# Section G: Change Pack

Comm Reference:	2955.6 – MT – PO
Comm Title:	XRN5463 – Technical Debt reduction- Prime and Sub process enhancement – Detailed Design Change Pack
Comm Date:	17/01/2022

Link: [M03 BILLREADS V12FA](#)

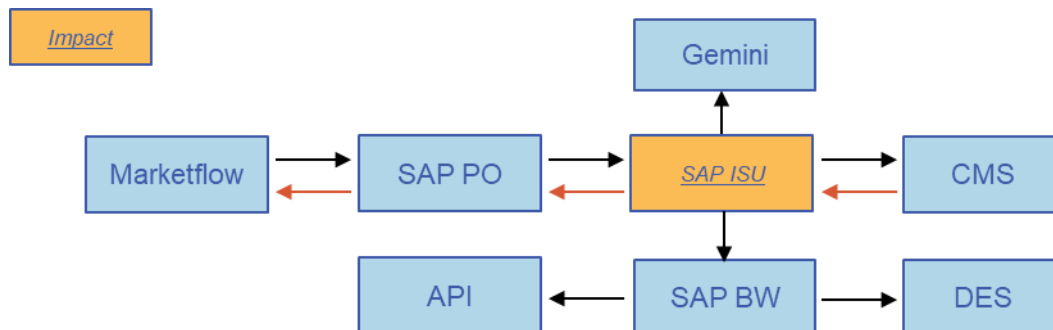
There will be the need for a documentation only change to the M03 record format to provide clarity on when the Reason Code of 'CYCL' can be used with a Read Type of 'E'. For the avoidance of doubt, there is no change to the M03 record, nor to the MBR file format, as this is already a valid combination. As per the attached, proposed, version of the M03, the Reason Code description will be updated as highlighted in red:

CYCL – Cyclic Reads, **Actual or Estimated**, (Prime & Sub Reads) / Estimated Read for Confirmation Effective Date in Back Billing Processes
